Re: Kettle Park West Traffic Impact Analysis Update Review

We have completed a review of the Kettle Park West (KPW) Traffic Impact Analysis Update (TIAU) completed by JSD Professional Services, Inc. (JSD) dated February 29, 2016. After an initial review of the TIAU, we asked for clarification on several aspects of the study. JSD subsequently provided a revised TIAU on March 30, 2016. This letter summarizes our review of the revised TIAU and our recommendations.

To: Rodney Scheel, City of Stoughton
From: Bill Dunlop, JSD
Re: Traffic Impact Analysis - Update
JSD Project #: 15-7018
Date: 12 April 2016
cc: Jeff Held, Mark Fisher, Strand; Dennis Steinkraus, FDG; Dave Jenkins, Adam Watkins; JSD; Jeff Fait, TADI

SHEET TITLE:
**JACKSON STREET
PAVING/STORM SEWER
PLAN AND PROFILE
STA 49+00 TO 52+50**

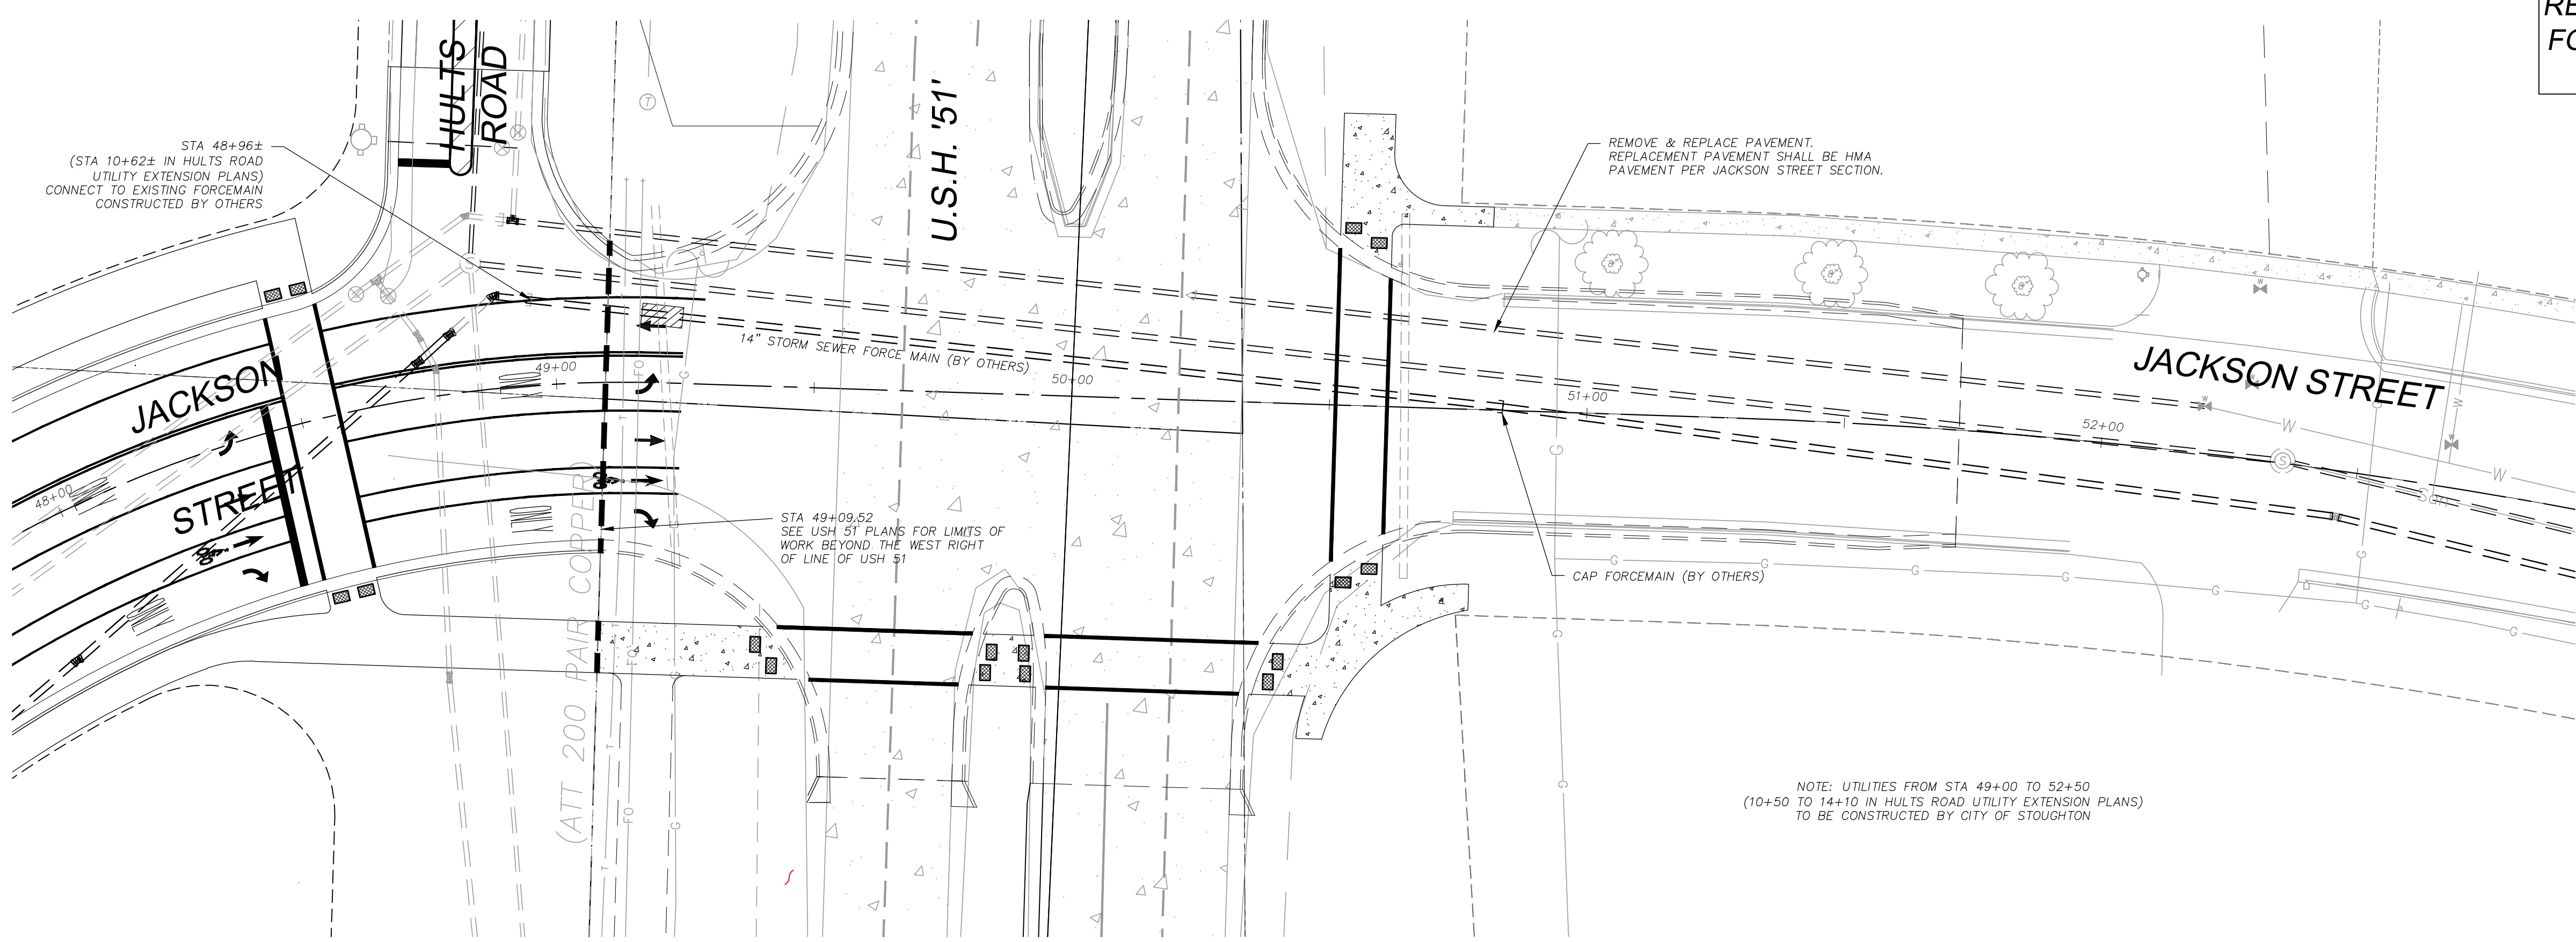
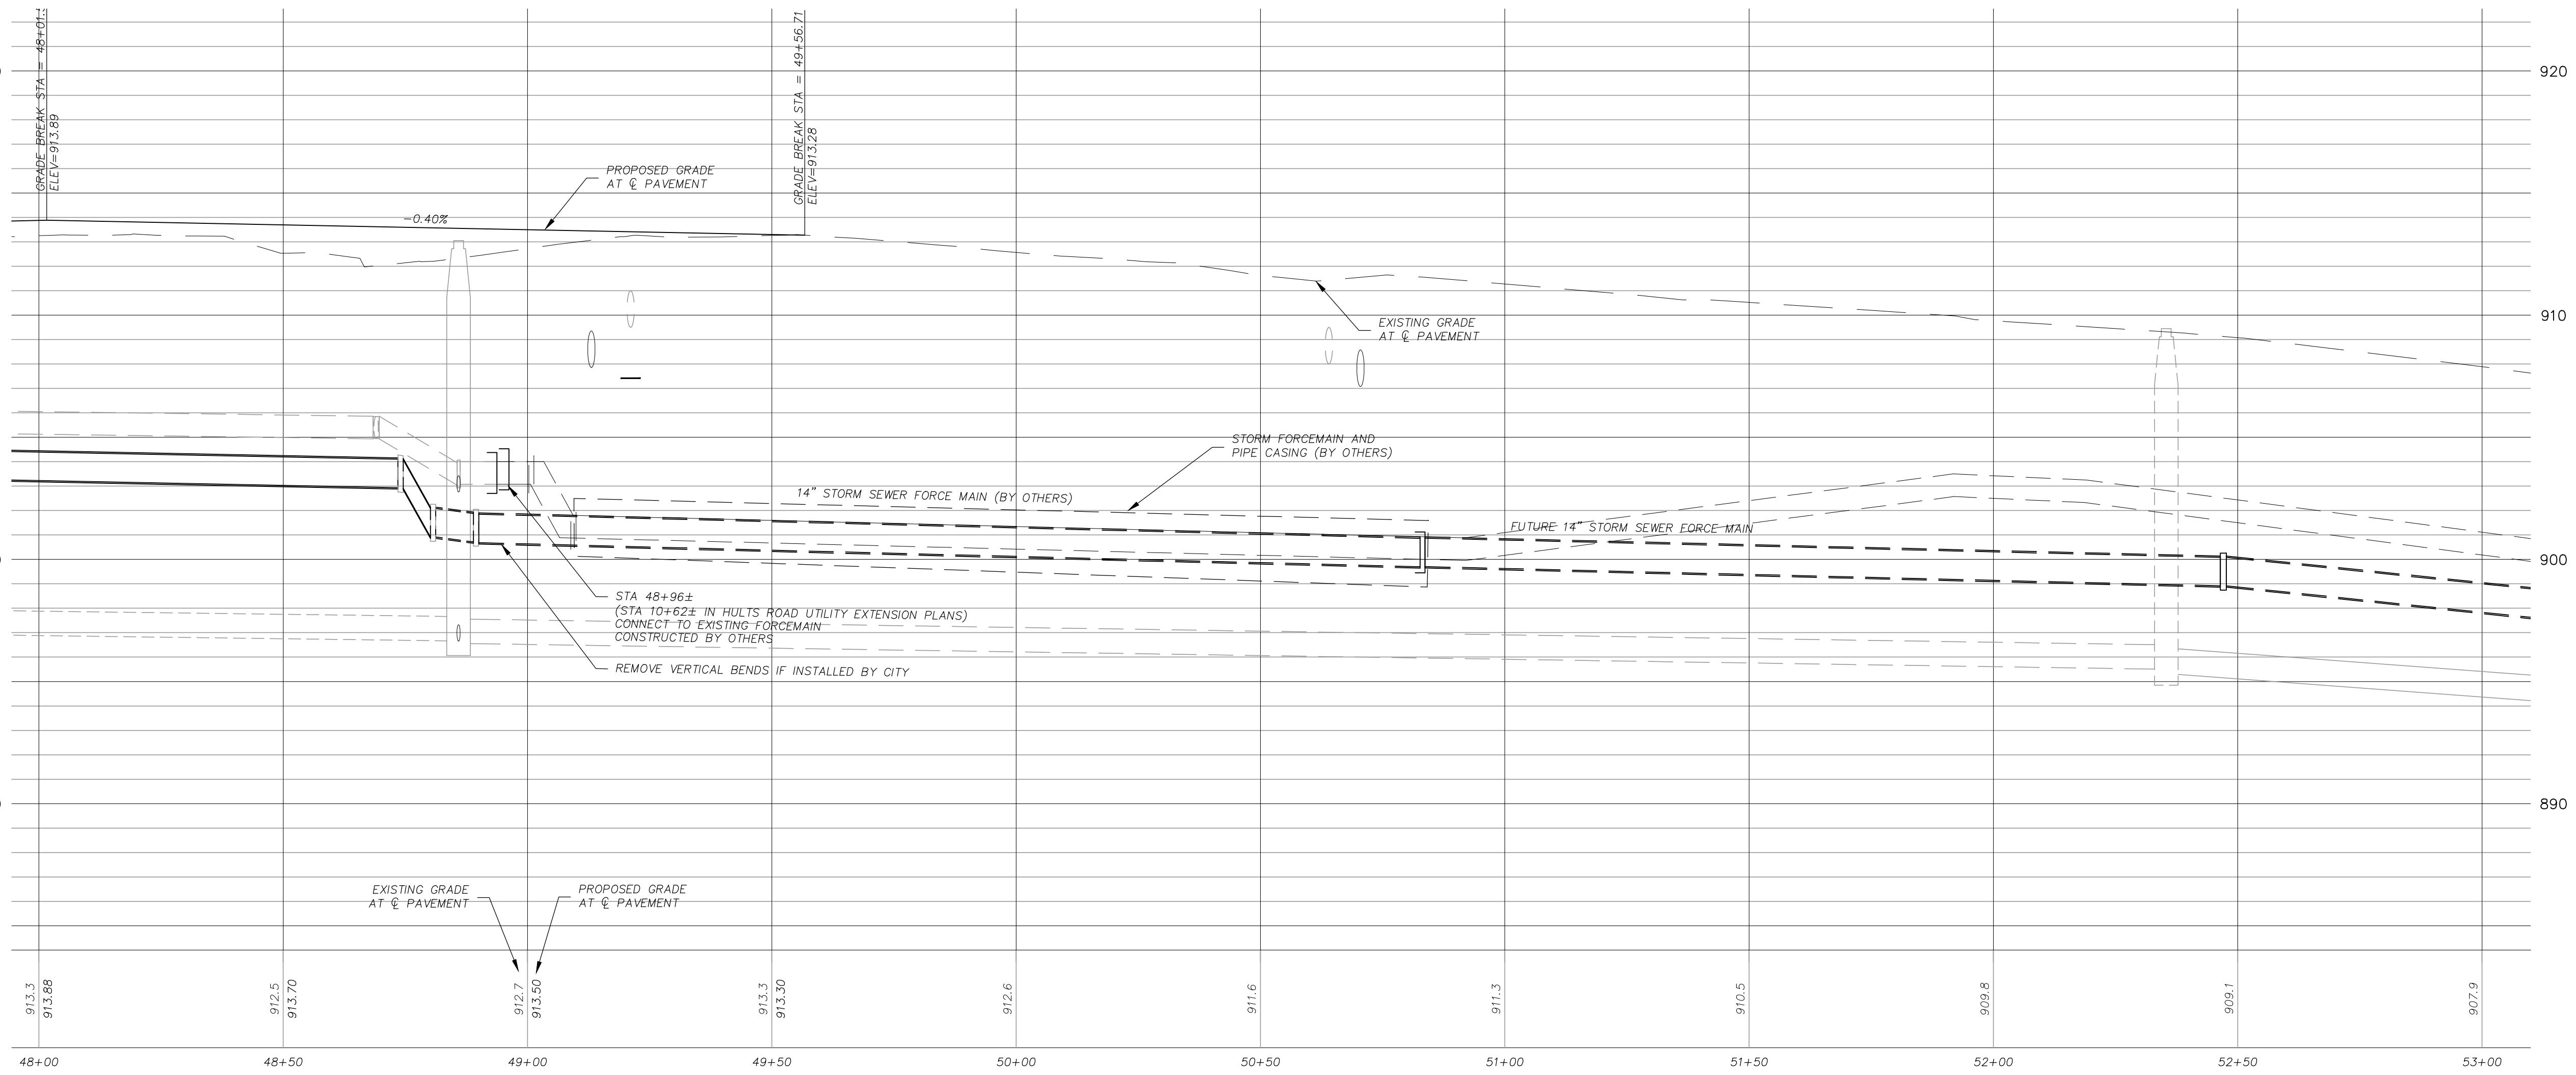
1. Trip Generation – No comments or response.
2. Trip Distribution and Assignment - No comments or response.
3. Traffic Modeling Results –
 - a. We requested the model used by the reviewer to compare methodology. The model provided to the reviewer did not reflect the approved lane configuration for the west leg of Jackson Street at the intersection with USH 51/Hults Road. The west leg modeled in the TIA – Update had a left turn lane, a thru lane and a right turn lane. This matches the attached plan sheets approved by the City and DOT and which has been constructed. The model provided to the reviewer had two lanes, a thru-left land and a right turn lane.

The difference in the model would most likely account for difference in level of service (LOS) between the two analyses at the Jackson Street intersection in the 2035 analysis.
